# ENDL TEXAS

Date: 24 June 2004  
 To: T10 Technical Committee and SNIA OSD TWG  
 From: Ralph O. Weber  
 Subject: Rewrite of OSD Security and Policy/Storage Manager Models

**Figure 1 — Example OSD Configuration**

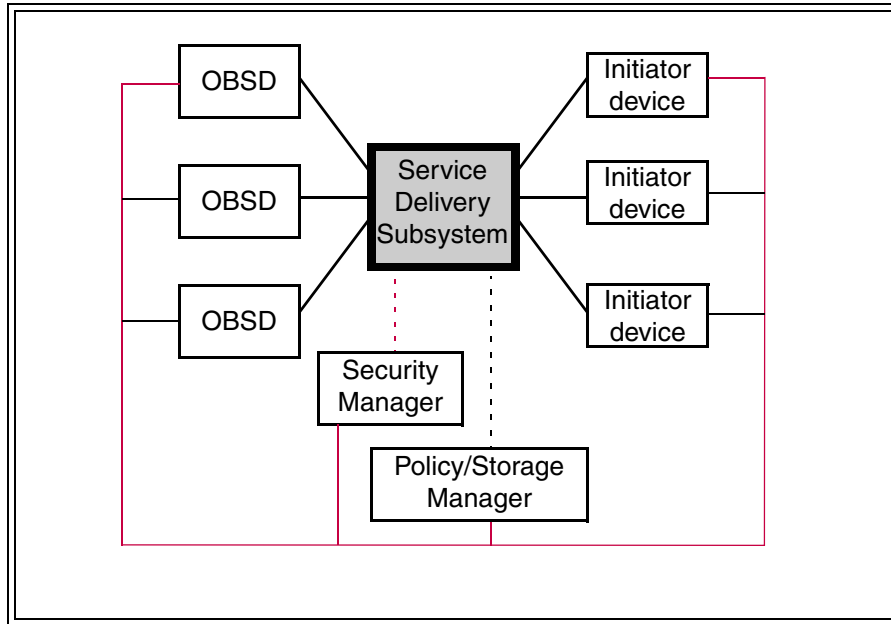
The security manager, if present, ~~coordinates access~~ **secures access capabilities in cryptographically protected credentials between** for OSD device servers and application clients (see 4.9). The security manager may use the service delivery subsystem and be an application client, but the security manager also may use another mechanism to communicate with the OSD device servers and application clients. When sending credentials to an application client, the security manager shall use a private, authenticated communications mechanism. The security manager may reside in the OBSD, in applications clients, or as a separate entity, but the security requirements on the communications mechanism shall not change based on the location of the security manager.

The policy/storage manager, **if present, coordinates access constraints between OSD device servers and application clients (see 4.x).** ~~maintains storage policies in a manner that is outside the scope of this standard.~~

Figure 2 — OSD security model transactions

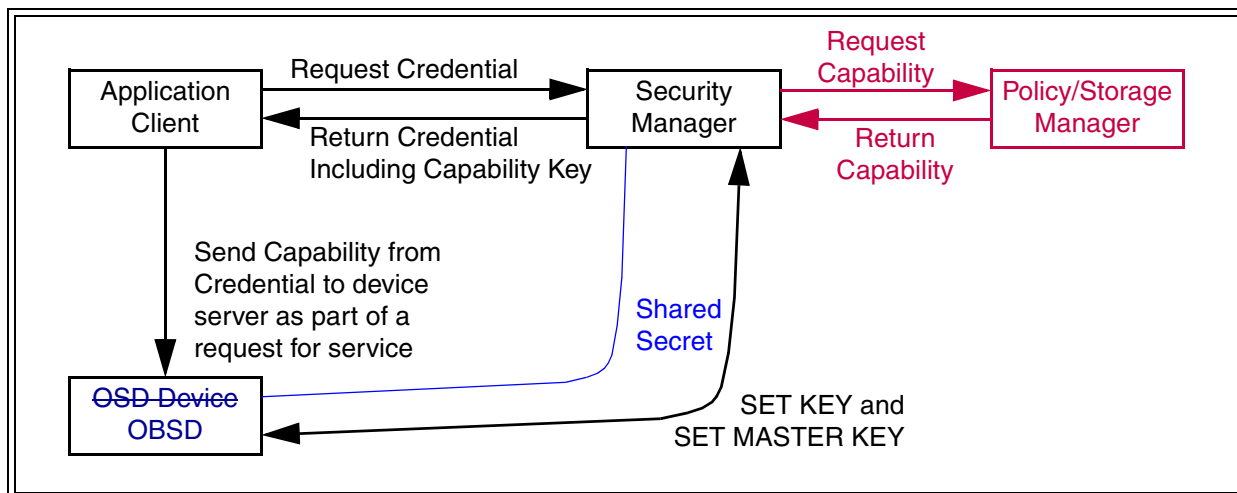
The security manager generates credentials, including capabilities prepared by the policy/storage manager, for authorized application clients at the request of an application client. The security manager returns a capability key with each credential. The credential gives the application client access to specific OSD components. The capability key allows the application client and device server to authenticate the commands and data they exchange with an integrity check value (see 4.9.7).
